Sydney North Planning Panel Meeting 11 December 2025
S4.55(2) MODIFICATION TO APPROVED RESIDENTIAL FLAT BUILDINGS AT 14-16
MARSHALL AVENUE, 2-10 BERRY ROAD, AND 5-9 HOLDSWORTH AVENUE, ST LEONARDS
SOUTH.

Record No: DA23/56-01 - 44553/25

Panel Reference	PPSSNH-647
DA No:	DA56/2023
LGA:	Lane Cove Council
Project description:	Construction of 3 residential flat buildings (14-storeys) comprising a total of 225 dwellings and basement parking for 345 vehicles.
Street Address:	14-16 Marshall Avenue, 2-10 Berry Road, and 5-9 Holdsworth Avenue St Leonards South.
Applicant/Planner/Owner:	Applicant: DASCO PROPERTY DEVELOPMENT SERVICES PTY LTD – Jack Maalouf Planner: Anna Wang – Urbis Owner: Marshall Land Pty Ltd as Trustee for Marshall Land Unit Trust & Holdsworth Land Pty Ltd as Trustee for Holdsworth Land Unit Trust.
Date Lodged:	18/06/2025
Total number of Submissions Number of Unique Objections	4 unique submissions have been received, 3 by way of objection and 1 in support of the application. - All submissions have been forwarded to the SNPP
Regional Development Criteria (Schedule 6 of the SEPP (Planning Systems) 2021	The Development is considered regionally significant in accordance with

Figure 18: View analysis corridor. (Source: Applicant)

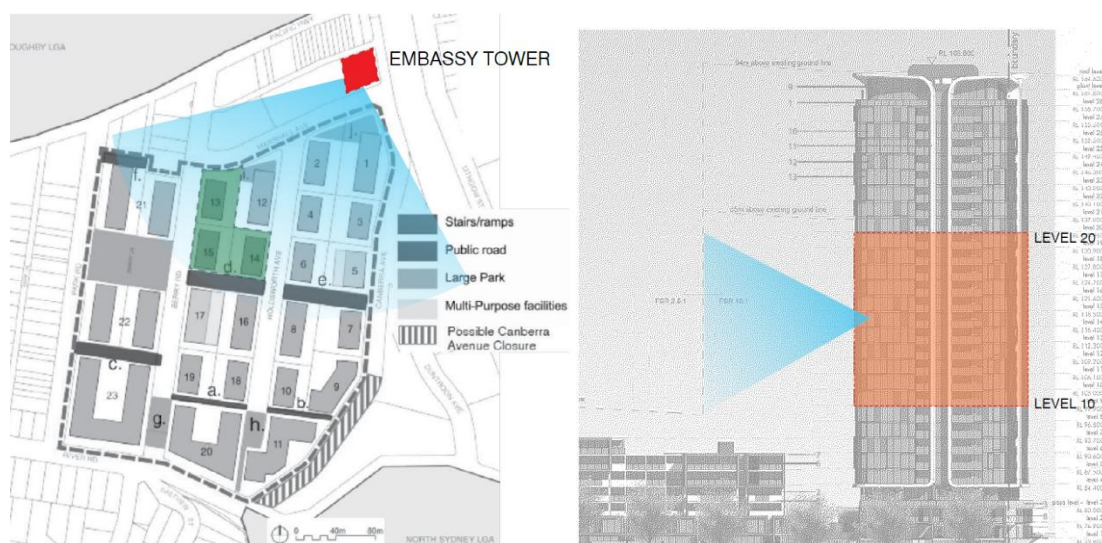
The southern views enjoyed are to the Harbour Bridge, North Sydney City skyline by the units around Level 10 and above which has been demonstrated in **Figure 18 – Figure 23**. Views to the foreground (short to mid-range) are to the existing residential flat buildings and landscaping in surrounding suburbs. Sections of the North Sydney and CBD skylines are also visible including the upper portion of the Sydney Harbour Bridge. Views to the southwest are to Sydney Harbour and Parramatta River and towards Sydney suburbs of Drummoyne, Five Dock, and Concord. Refer to **Figure 18 – Figure 23** including internal photos and unit floor plan. Views are classified as **high value**.

Figure 23: Approved development (right image) Proposed development (left image) (Source: Applicant's View Loss Analysis)

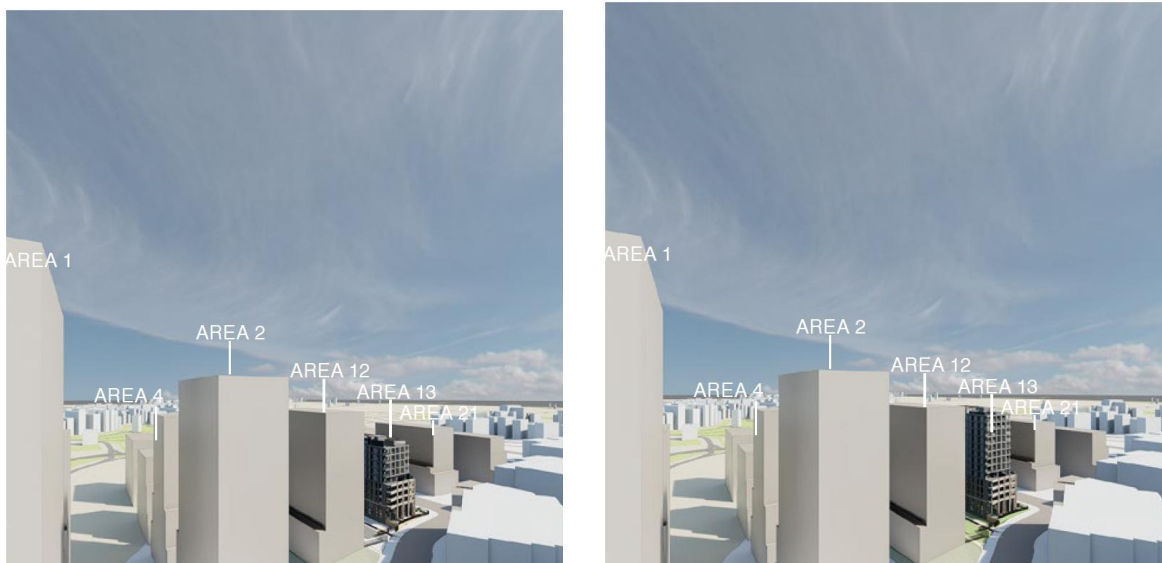
The Significant views obtained from Levels 20 and above would not be impacted by the proposed developments. The development would be predominately obstructed by the approved buildings in Areas 2 and 12. A partial suburban district view would be impacted which is considered negligible.
